## ADDENDUM NO. 2

PROJECT: Bannack State Park Detention Basin Project

FWP PROJECT #: 7116103

DATE: 02/28/17

SHEET  
6-1

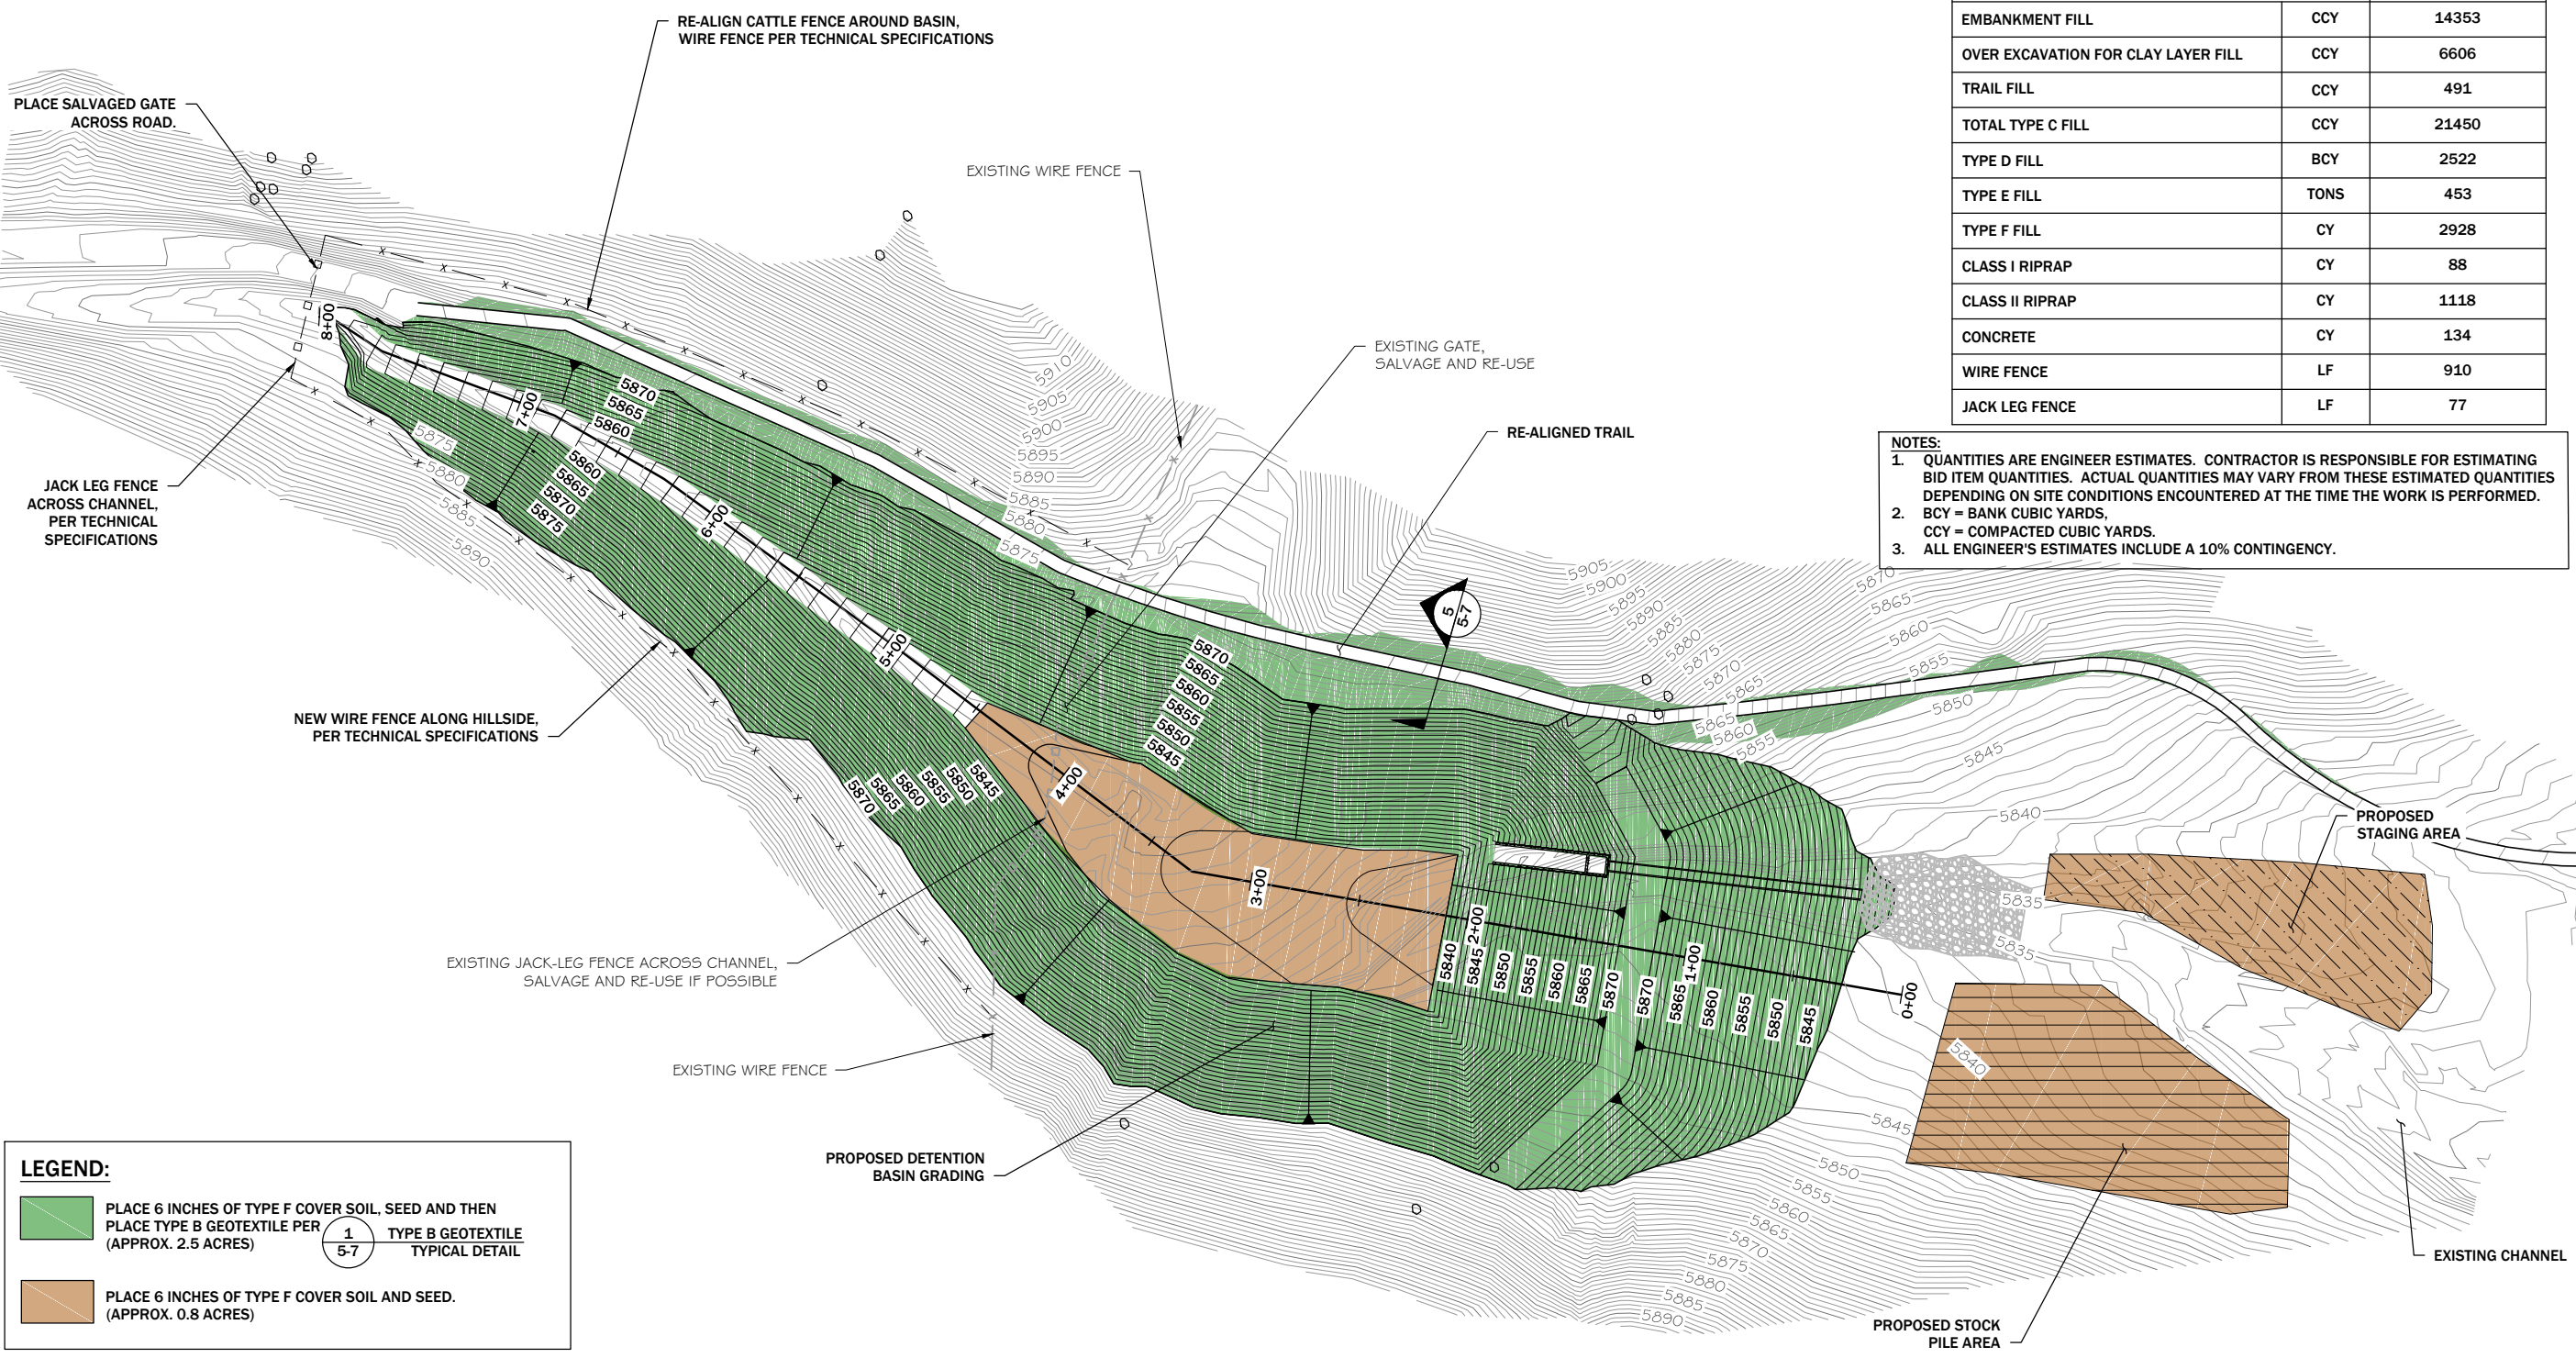
2. **Question:** Do the quantities on Sheet 6-1 include additional excavation and subsequent fill required to remove clay layer?

22. **Question:** Do you have estimated quantities for the access routes, realigned road, staging area, or stockpile area? All we see is the breakdowns for the retention pond.

1. **Sheet 1-3:** Added approximate length of road to be reclaimed after work is complete.
2. **Sheet 4-6:** Added permissible construction joint locations.
3. **Sheet 5-2:** Updated quantity table to include inlet channel over-excavation, added maximum excavation slope of 1.5H:1V for over-excavation note and added cross sectional areas for clay layer and overburden material.
4. **Sheet 5-7:** Added Fence Typical Detail.
5. **Sheet 6-1:** Revised quantity table and areas to clarify quantities and to reflect a more accurate estimate of proposed work.

**Response:** The quantities on sheet 6-1 do include the over excavation required to remove the clay layer. The revised quantity table on Sheet 6-1 (included in this addendum) provides a breakdown of excavation and fill quantities.

**Response:** The areas on the lower left hand side of sheet 6-1 include the embankment/basin, trail re-alignment, staging and stockpile areas. The access route is along an existing road and is to be reclaimed to pre-construction condition. The extent of reclamation on the road is dependent on the extent of disturbance and widening required for the Contractor to access the site. It is ~1,300 lf from Bannack Road to the start of the trail re-alignment.
